#28 COMBO PLUMBING SCHEMATICParts List

PART NO: 801308
DESCRIPTION: #28 COMBO PLUMBING SCHEMATIC

PART NO: A801302
DESCRIPTION: #28 HOSE KIT

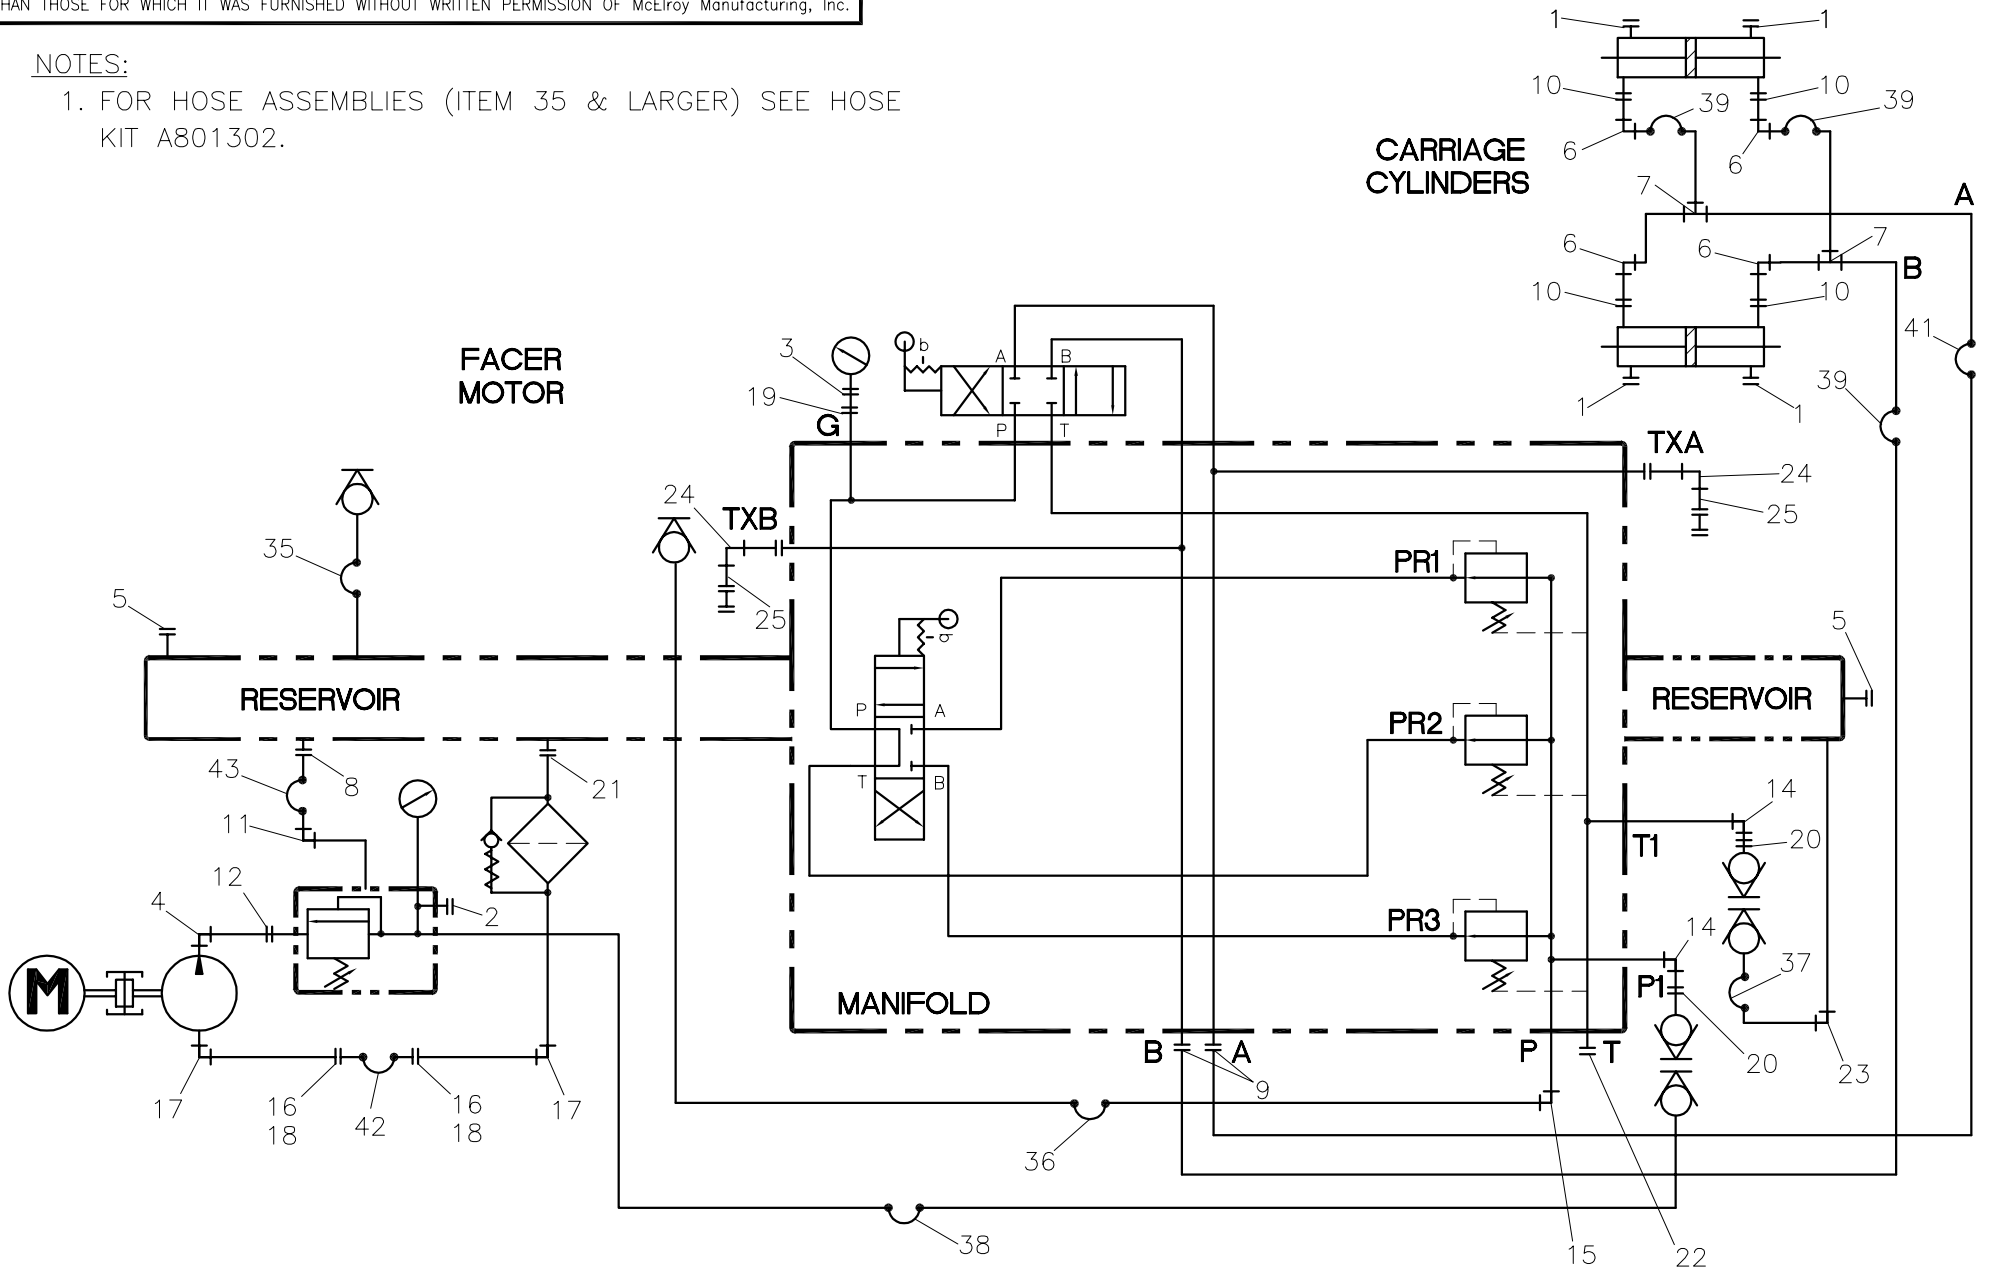
<u>APPR.</u>	<u>REV</u>	<u>DATE</u>	<u>BY</u>	<u>DESCRIPTION OF REVISION</u>
SWB	A	8/10/98	DJL	ITEM #10 MFI00011 WAS NOT LONG ENOUGH. REPLACED WITH MFI00125, 3 1/2" LG. NIPPLE.
TLW	----	11/16/98	MLM	CHANGED (MFI00009) 2" TO (MFI00094) 2-1/2" LG PIPE NIPPLE FOR MORE CLEARANCE WITH DIRECTIONAL VALVE ON TOP OF MANIFOLD.
LAF	B	05/5/99	AH	REVISED SCHEMATIC FOR NEW HYDRAULIC MOTOR MEC00021. DELETED ITEM #13(MFC00068) ADDED ITEM #13(MFA00195) QTY 2. ADDED ITEM #25(MFA00192) QTY 2.
SWB	C	06/12/02	BWW	REVISED TO REMOVE ITEM 13 MFA00195, AND ITEM 25 MFA00192. PARTS MOVED TO 840601 FACER HYDRAULIC/PLUMBING SCHEMATIC. REMOVED ITEM 19 MFI00007, PART WAS NOT NEEDED. CHANGED QTY OF ITEM 20 MFI00094 FROM 1 TO 3 AND CHANGED ITEM 14 FROM MFC00070 TO MFC00115 TO ACCEPT EXTENSION HOSE KIT 1219107.
SWB	D	03/12/04	BWW	REVISED QTY OF ITEM 20 MFI00094 FROM 3 TO 2 AND ADDED ITEM 19 MFI00011 QTY 1 FOR CLEARANCE WITH CONTINENTAL VALVE. CORRECTED DESCRIPTION FOR ITEM 21 MFI00041 TO MATCH AS400.

SWB	E	11/07/05	BWW	MOVED NOTE TO FACE OF DRAWING FOR CLARITY. REMOVED ADL1401 WHICH IS NO LONGER NECESSARY, ADDED NEW ITEM 24 MFC00113 QTY 2 AND ITEM 25 MFH00048 QTY 2 FOR NEW DATALOGGER.
